Permit Number: 080964

has permission to add a room to existing 2 story space

AT 856 BRIGHTON AVE

Reference:
Breakwater School
856 Brighton Ave.
Portland, ME 04103
SI Job #: 09-0010

CANTILEVER DETAILS

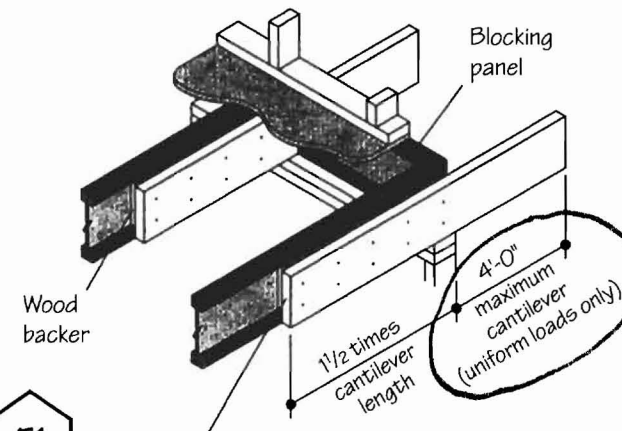
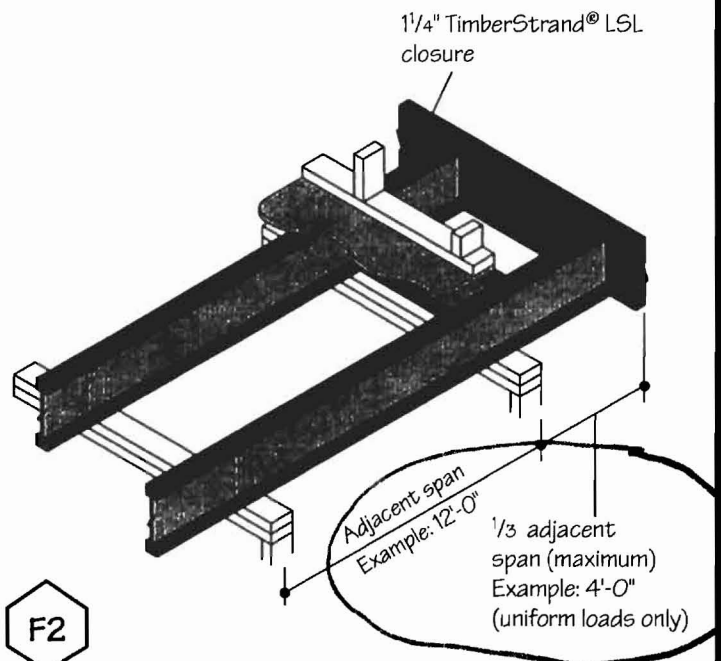
9/8/2008-jmb: Spoke with Ian S. For design specs on the balcony guardrail system and the floor system cantilever, he will provide

9/10/2008-jmb: Received details

ROOM OVER STAIR

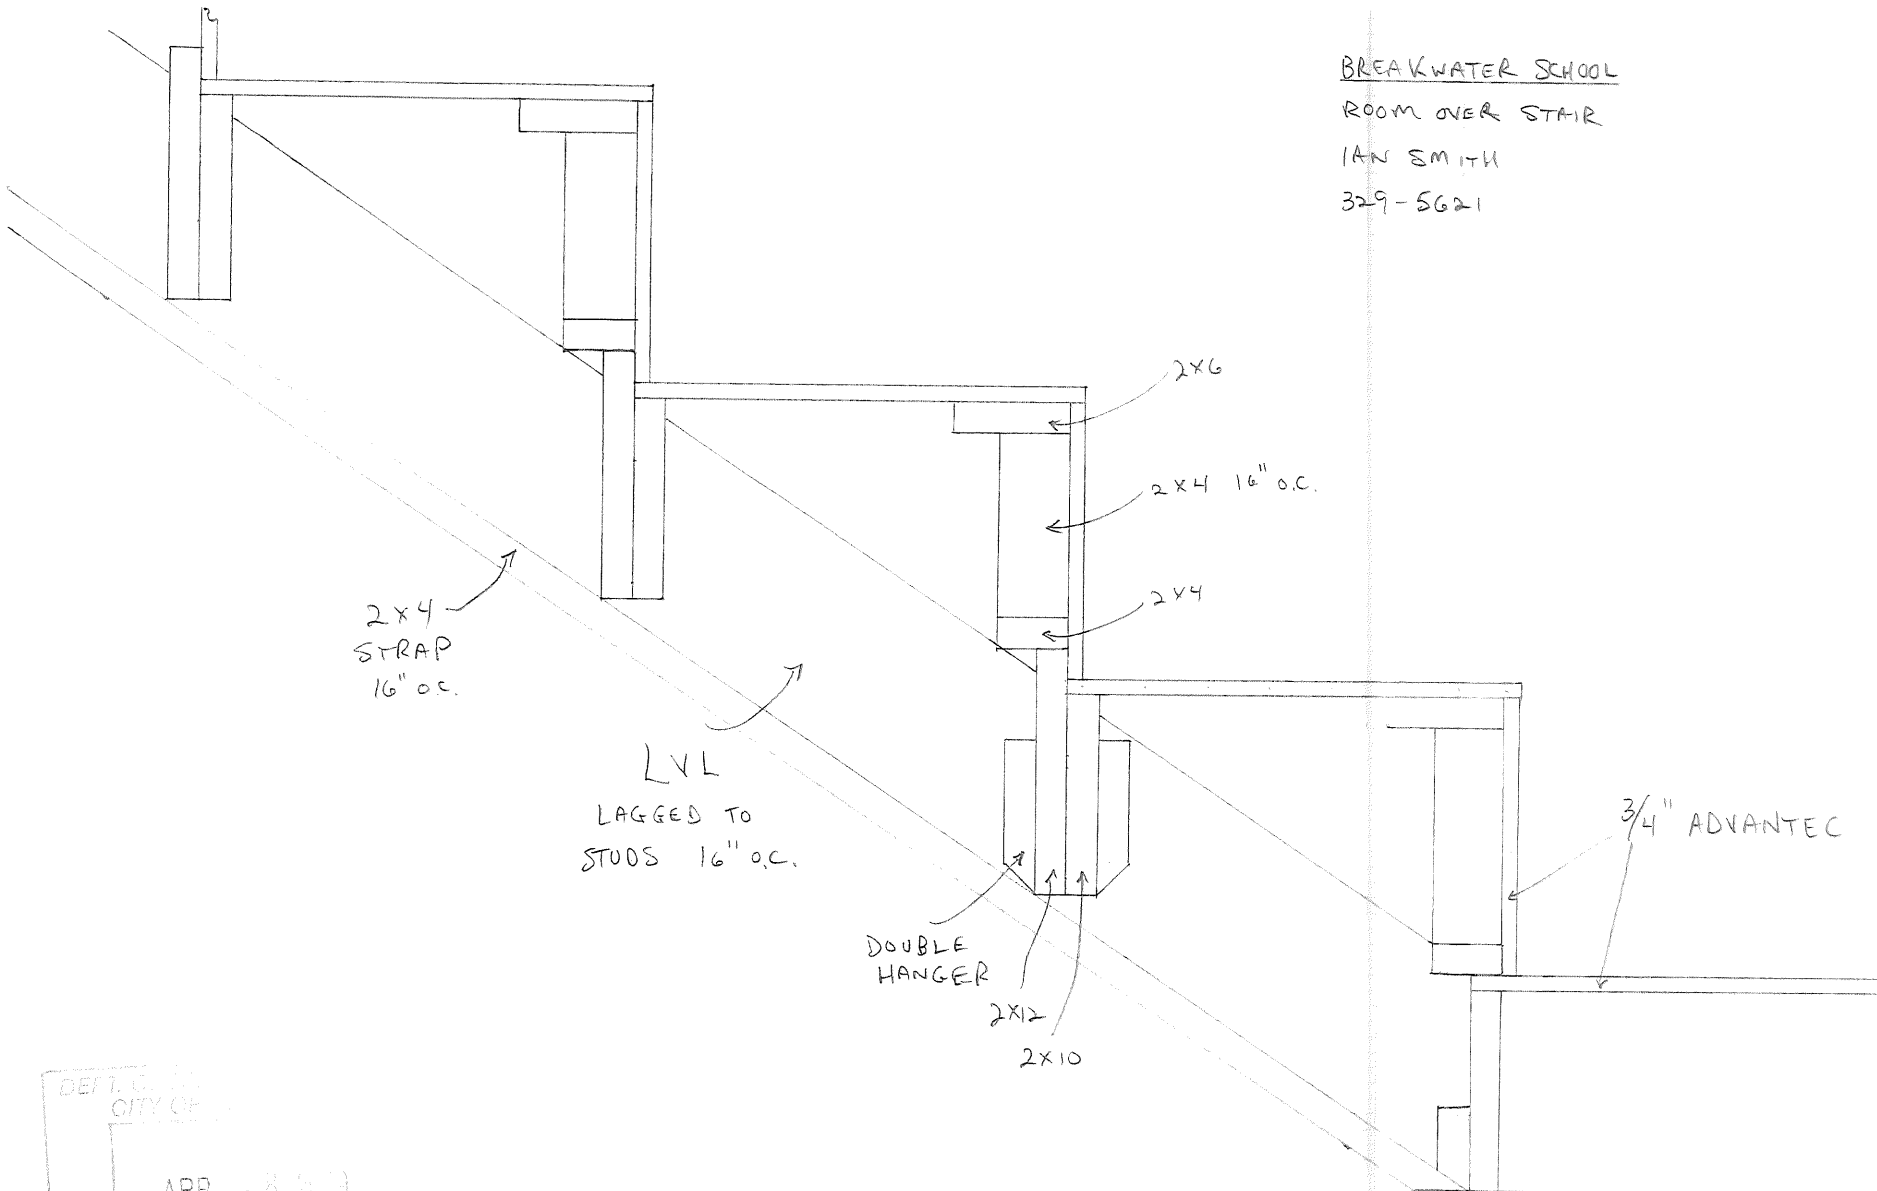
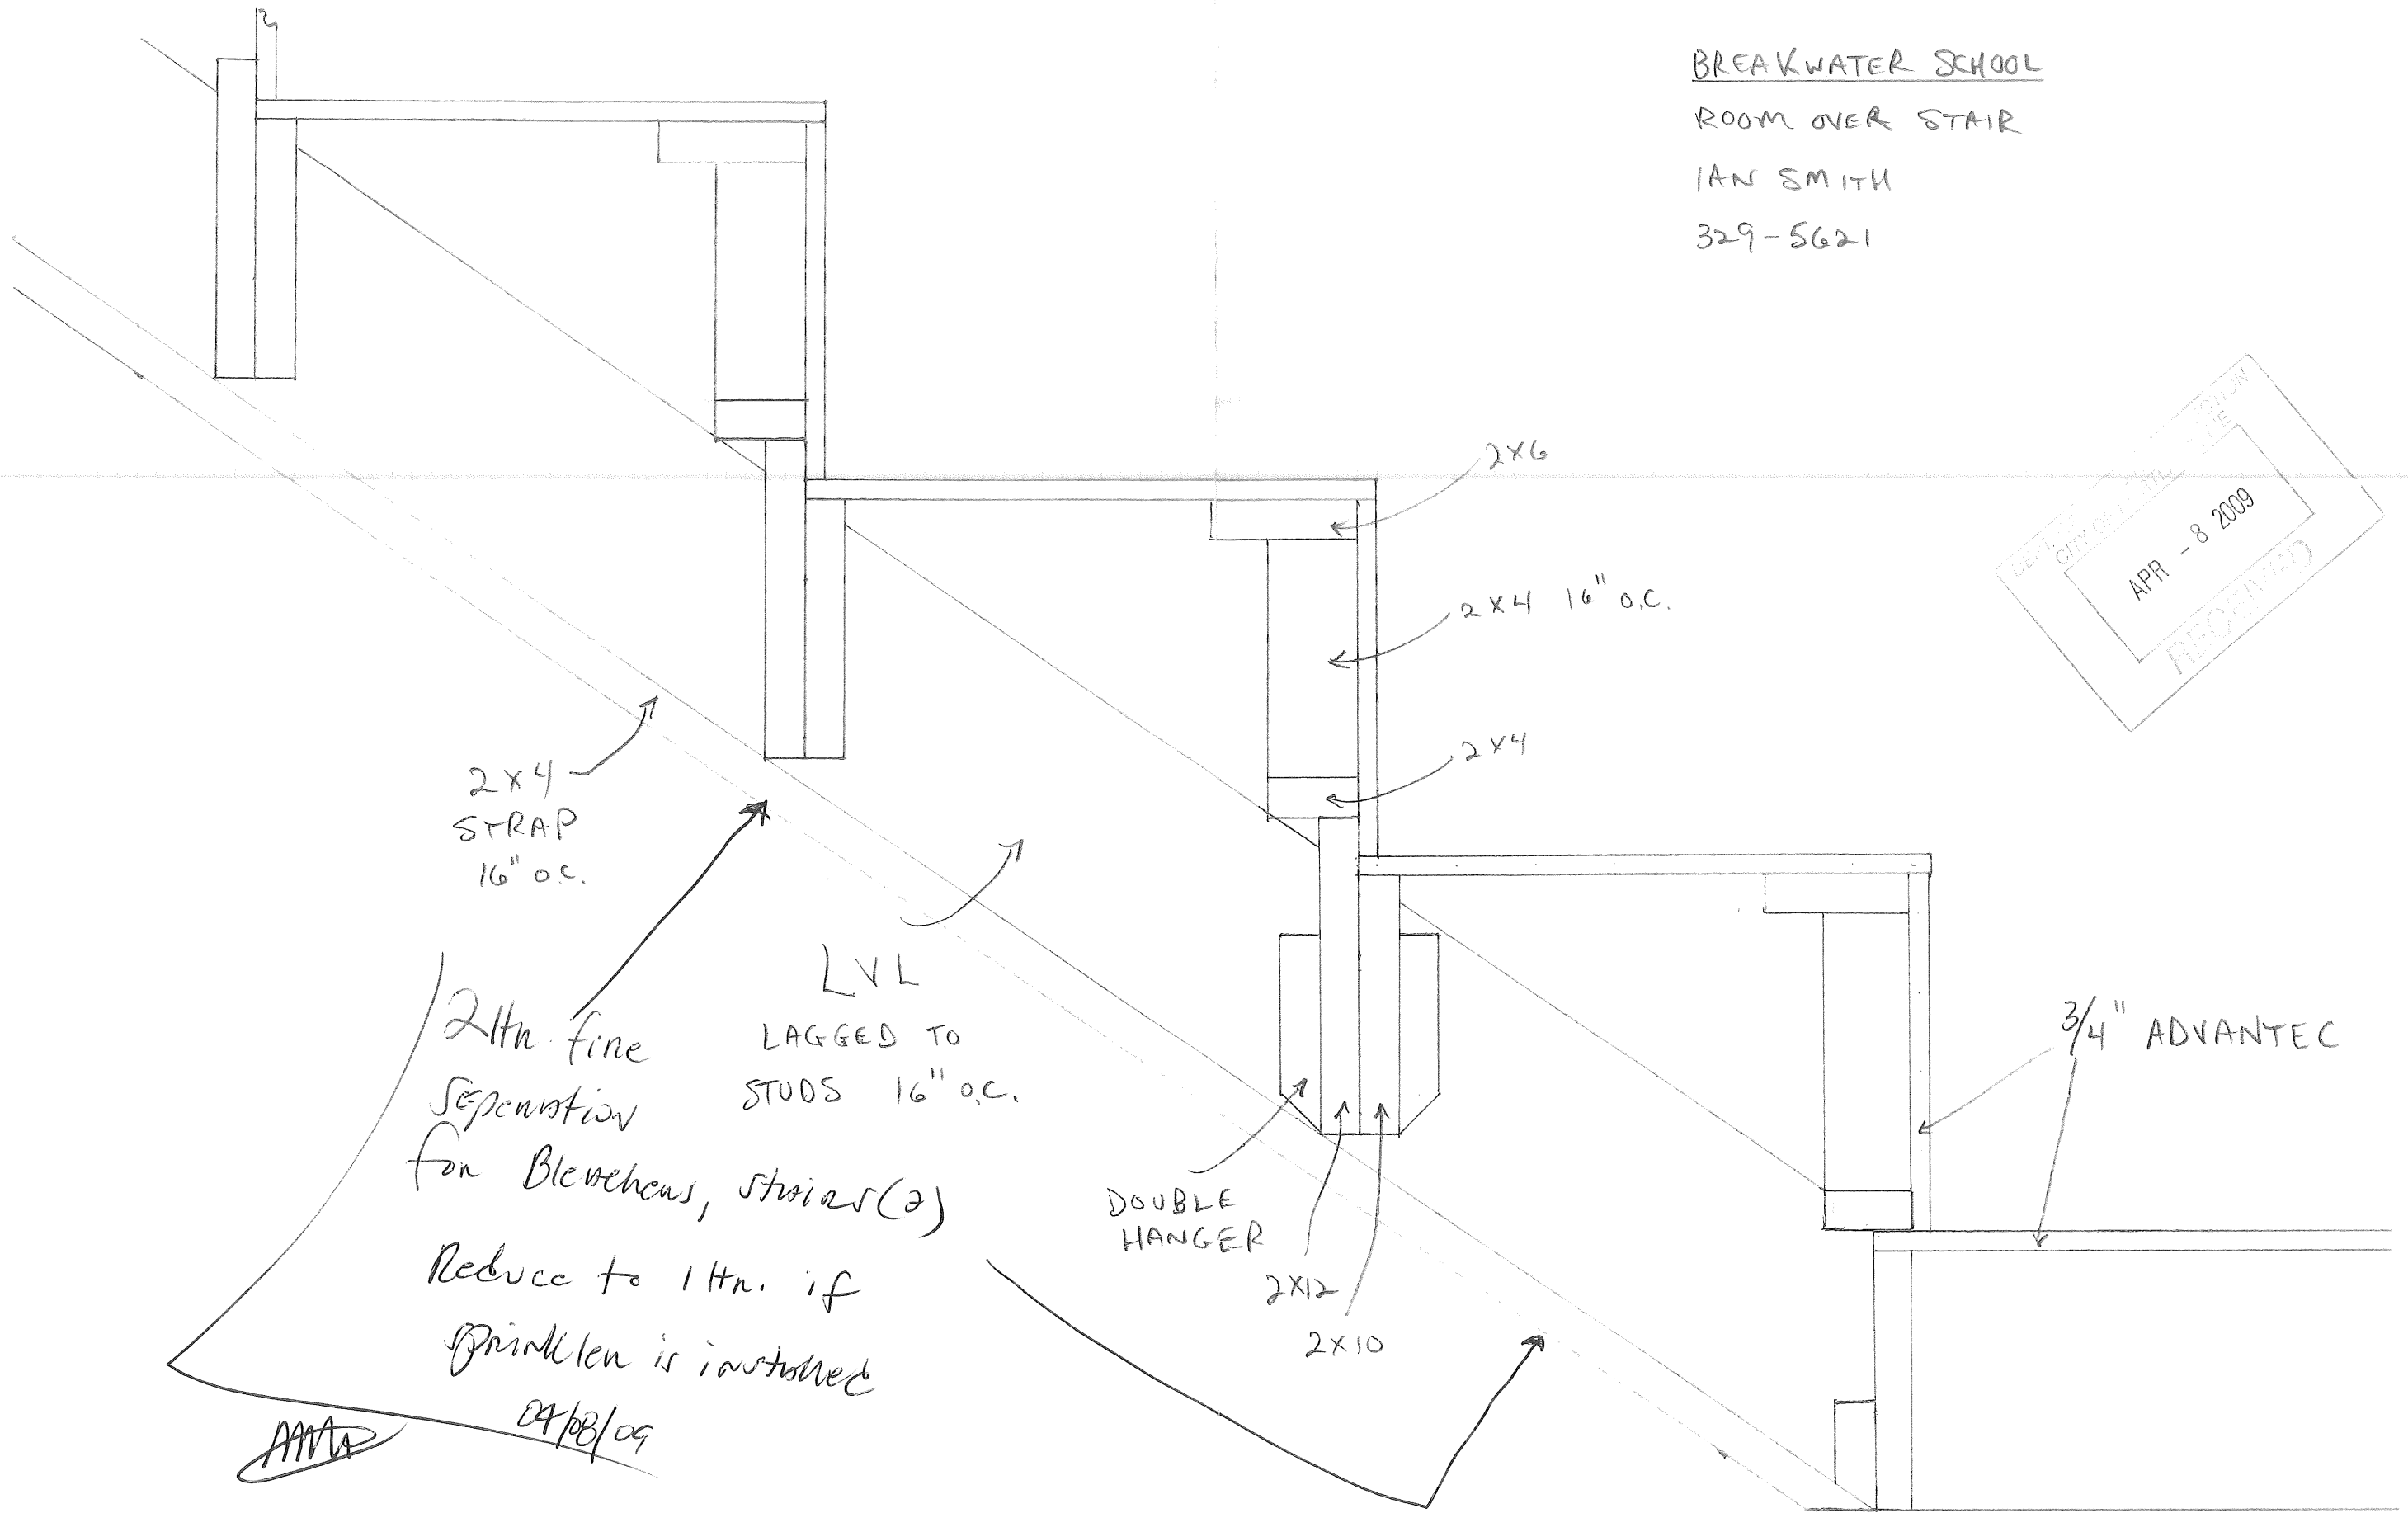
As requested I am writing this memo regarding the fixed in place seating area above the existing stairwell at the above referenced site. The opinions expressed are based on calculations performed, limited visual observations during my visit to the site on February 11, 2009, my knowledge of structures, their components and the related building codes.

While on site I observed the in place framing consisting of double 2x joists, (1) 2x10 and (1) 2x12, with 3/4" sheathing. The double 2x joists are hung from an LVL ledger with an LUS210-2 hanger each end. The LVL ledger is fastened to the existing wood stud bearing wall with (2) Timberlock wood screws per 16".

Based on my calculations the contractor, Ian Smith, was instructed to place (2) additional Timberlock wood screws per 16" into the LVL ledger at the wood stud bearing wall. With (4) Timberlock wood screws per 16" at the ledger attachment the in place framing of the structure meets the requirement of 100psf live load for bleachers per the 2003 IBC.
